IMPORTANT RECALL INFORMATION #80519

**SUBJECT: RECALL CAMPAIGN #80519
2004, 2005, 2006 JAMBOREE GT & TIOGA SL CLASS C
PROPANE PIPE RELOCATION**

RECALL BULLETIN:
80519

SUBJECT:
Reroute
Propane
Plumbing
Away From
Chassis
Suspension

Figure 1

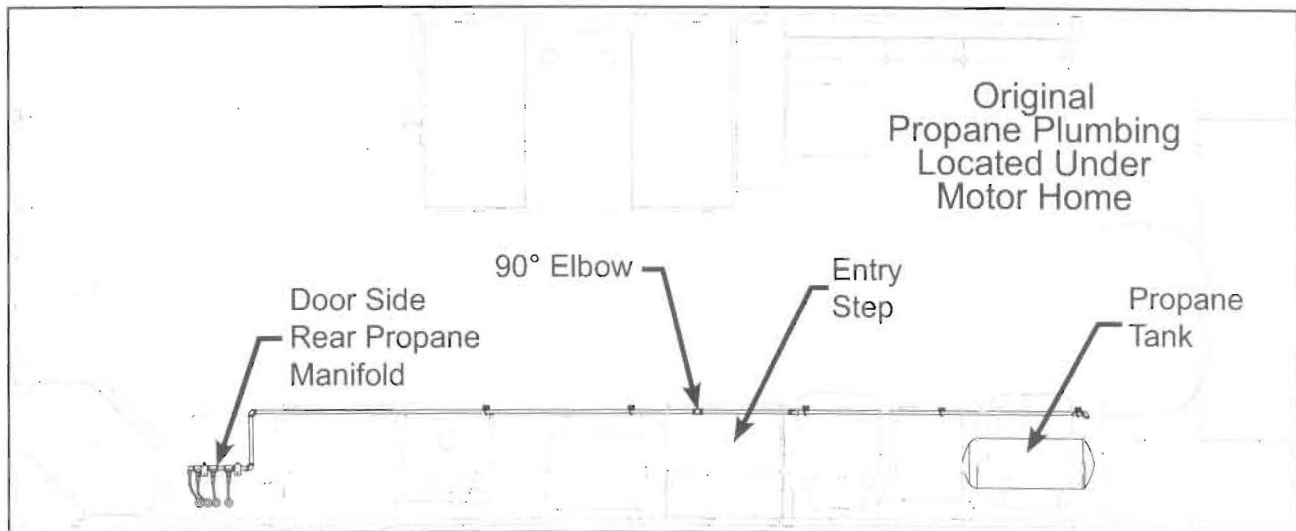
12. Remove the door side rear Propane manifold assembly by unthreading the forward manifold Tee from the forward Propane distribution pipe. Use care to prevent debris from entering the manifold assembly. Clean debris from the Tee with a small wire brush. Cover the open Tee end of the door side rear Propane manifold with tape. Retain for later reassembly. See Figures 1 and 2.
13. Remove and discard the U-bolt clamps securing the Propane plumbing between the door side rear Propane manifold location and the rear side of the entry step. Hanger Brackets will be reused during reassembly. See Figure 1.

14. Remove and discard the plumbing from the Propane manifold location forward of and including the 90° elbow, near the rear side of the entry step. See Figure 1.

Figure 2

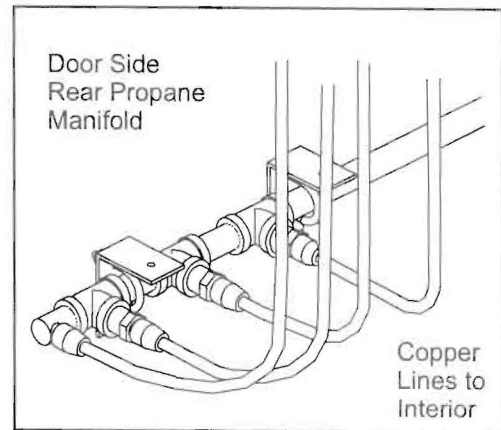
10. Remove and retain all door side rear Propane manifold hanger hardware.
11. Use a small wire brush to clean dirt, debris, rust accumulation, and any undercoating from the pipe fitting at the forward end of the Propane manifold. See Figure 2.

Figure 3

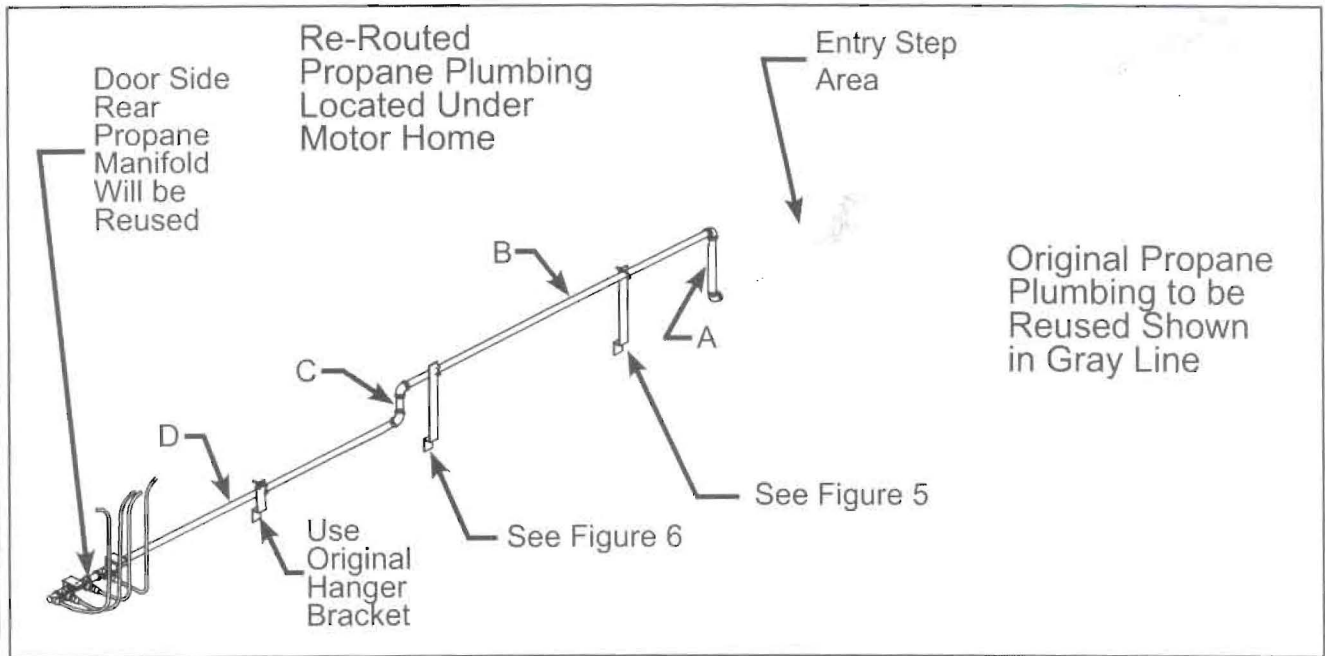
8" (Figure 3, Reference "A")
45 1/2" (Figure 3, Reference "B")
4 1/2" (Figure 3, Reference "C")

16. Use a small wire brush to clean the pipe threads of the original pipe located near the rear of the entry step. Install a new 90° elbow on the end of this original pipe. Tighten the elbow until it is pointing straight up. See Figure 3.

17. Attach the straight end of the new 8" length of pipe to the 90° elbow installed in Step 16. Tighten the pipe until the elbow on the opposite end points toward the rear of the motor home. See Figure 3, Reference "A".
18. Mark the outrigger, on the forward side of the wheel well, for a hole that will allow a new pipe to be aligned with and connected to the 90° elbow of the 8" length of pipe. Refer to Reference "B" in Figure 3 and the photo in Figure 4.

Figure 4

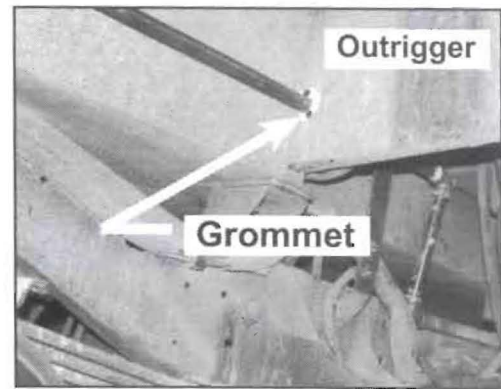
19. Drill a 1 1/4" hole through the outrigger using a hole saw.
20. Apply Bostic sealant around the edge of the new hole in the outrigger and install a grommet. Secure the grommet with two #8 X 3/4" Tek Screws. See Figure 4.
21. Route the straight end of the new 45 1/2" length of pipe through the grommet in the outrigger and attach to the 90° elbow on the length of pipe, installed in Step 17. Tighten the pipe until the elbow on the opposite end points down. See Figure 3, Reference "B".

Figure 5

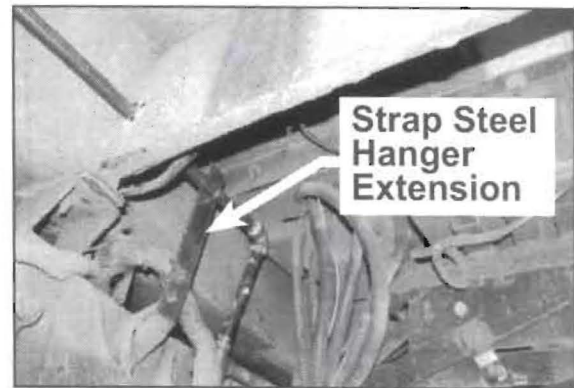
22. Install a 1 1/2" X 10" X 1/8" Strap Steel Hanger Extension to each of the two original Propane plumbing hanger brackets according to the locations in Figure 3 and the photos shown in Figures 5 and 6. Drill 5/16" holes in the Strap Steel as necessary and attach to existing brackets with two 1/4-20 X 1" Bolts, Flat Washers (2 each bolt), Lock Washers and Nuts each. Also Drill 5/16" holes in the Strap Steel for installation of the U-bolts.

24. Install U-bolts for the Propane plumbing at the two new Strap Steel Hanger Extensions. See Figures 5 and 6.
25. Attach the new 59" length of pipe to the 90° elbow on the end of the pipe installed in Step 23 and tighten. See Figure 3, Reference "D".
26. Remove tape installed in Step 12, from the Propane manifold and attach the manifold to the end of the 59" length of pipe. Tighten the manifold until the flare fittings align with the brass flare fittings removed in Step 9.
27. Re-install the original manifold hanger hardware removed in Step 10.

Figure 7

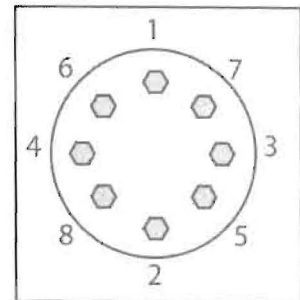
33. Reinstall the two right rear wheels. Refer to Figure 7 for proper lug nut tightening sequence. Tighten lug nuts until snug, then hand-torque to 140 ft-lbs., using the same tightening sequence.
34. Remove heavy duty jack stand.
35. Lower the motor home to the ground and remove the floor jack.
36. Advise the customer to verify the wheel lug nut torque on reinstalled wheels after 100 miles and again after 500 miles.
